Wheaton Library, Community Recreation Center and Neighborhood Park, Mandatory Referral, MR2016004

Completed: 10/2/2015

Proposed Site Layout

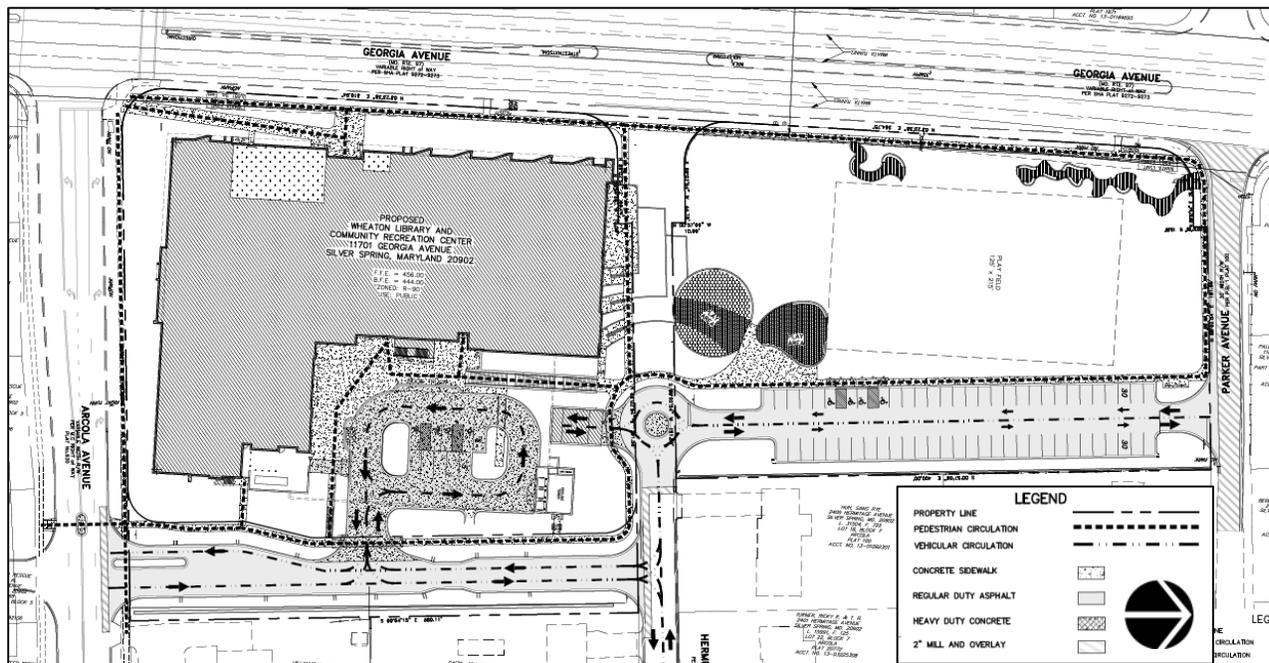
As currently proposed, the surface parking lot does not conform to this section of the Zoning Ordinance. The design does not provide any landscaped islands or protects and incorporates existing trees into the design of the parking lot. The location of the proposed elm trees along

the parking lot does not provide the minimum tree canopy of 25%. The surface lot is setback a minimum of 10 feet from the shared property line with residential uses to the east, and the existing fence along the property line will remain meeting the Zoning Ordinance requirement. The proposal does not include the specified canopy tree every 30 feet on center or understory trees along the shared property line; the area is proposed as a combination of grass sod and stormwater management facility.

As described in the paragraph above, the proposed surface parking lot does not meet some of the zoning requirements for landscaping and tree canopy. While landscaped islands are required by the ordinance, preservation of trees is also a strong desire and priority for this site. Staff recommends that the Applicant explore the feasibility of providing additional perimeter planting abutting residential properties.

As currently proposed, the application provides 78 onsite parking spaces than required by the Zoning Ordinance. Another 76 parking spaces are available for overflow parking across Arcola Avenue. Staff recommends the Applicants reduce the amount of surface parking area, which will allow more land area to accommodate other facilities and goals including playing field, landscaped islands, stormwater management facilities, tree canopy coverage and preservation of existing mature trees to meet the requirements and intent of the zoning section.

Proposed Vehicular and Pedestrian Circulation

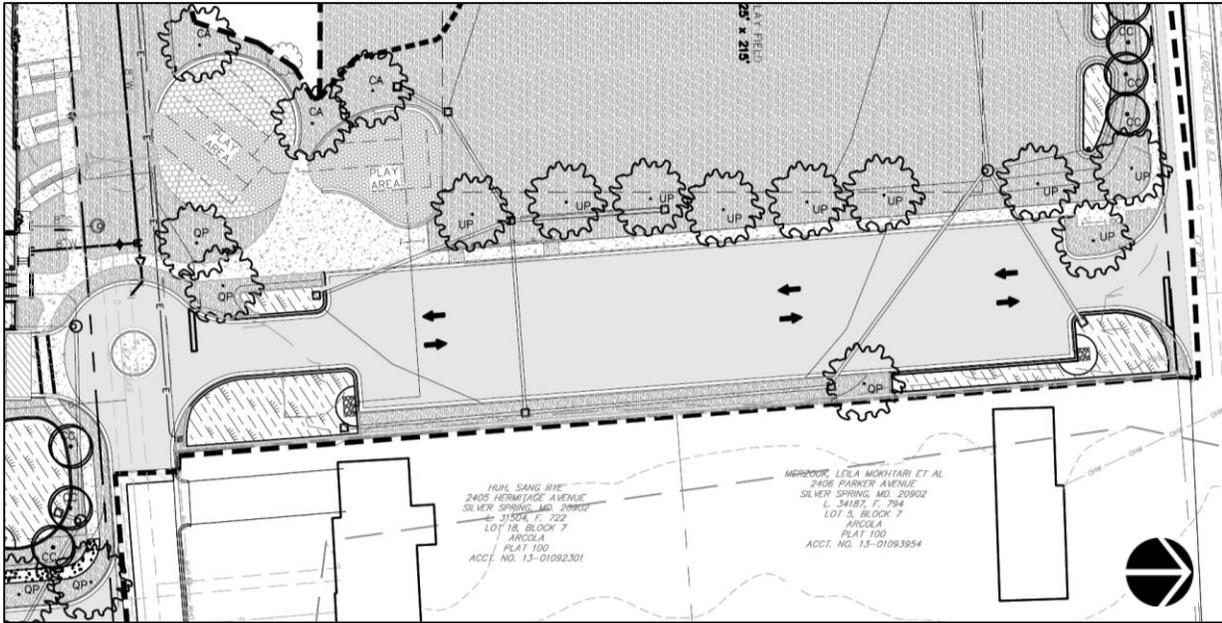
Vehicular circulation will be adequate, safe and efficient. Although the proposal includes the closure of a portion of Hermitage Avenue, the realigned Hermitage Avenue parallel to Georgia Avenue will provide adequate vehicular circulation for Hermitage Avenue traffic approaching Georgia Avenue. Sidewalks are proposed along the perimeter of the site and along the proposed roadway and surface parking lot. However, to improve the adequacy, safety, and efficiency of the pedestrian circulation, Staff recommends the sidewalk along Arcola Avenue be expanded to the standard five-foot width with a green panel and street trees at the perimeter of the site per the current Road Code standard. Staff also recommends the signed and marked crossing of Arcola Avenue be moved east of the intersection with the proposed roadway.
